#### Working Party on Road Traffic Safety

##### Group of Experts on Road Signs and Signals

## Report of the Group of Experts on Road Signs and Signals on its sixth session

### I. A sign-by-sign assessment by the Group of Experts

### B4 “END OF PRIORITY” sign

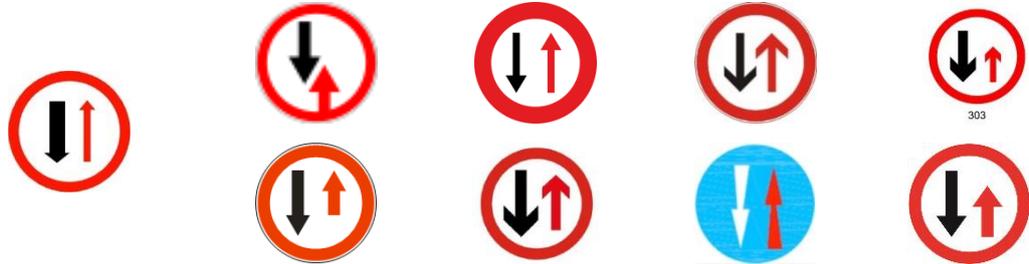
83. The Group noted that some countries do not use the black rim for the yellow square in the centre, and recommended that they do so.

**B6 Sign indicating priority over oncoming traffic**

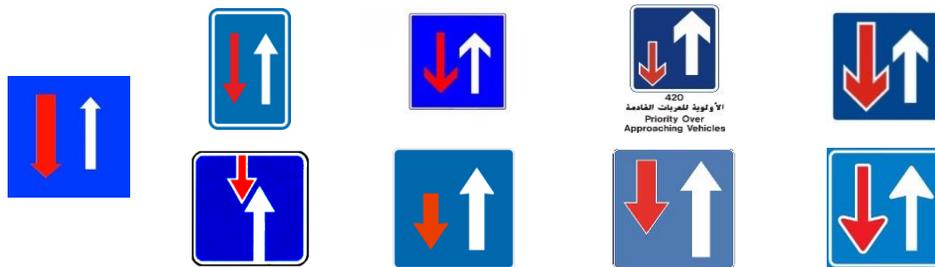
85. The Group noted that some countries do not use the arrows (ie length, width, positioning) as they appear in the Convention. The Group recommended that the arrowheads in the symbol used in Annex 3 of the Convention be enlarged, and that the signs of countries be in line with the revised symbol. The Group also recommended that the following additional words be inserted at the start of the article related to sign B, 6: “The sign indicating priority over oncoming traffic shall be sign B, 6.” To assist colour-blind drivers, the Group recommended that a white rim should be inserted around the red arrow.
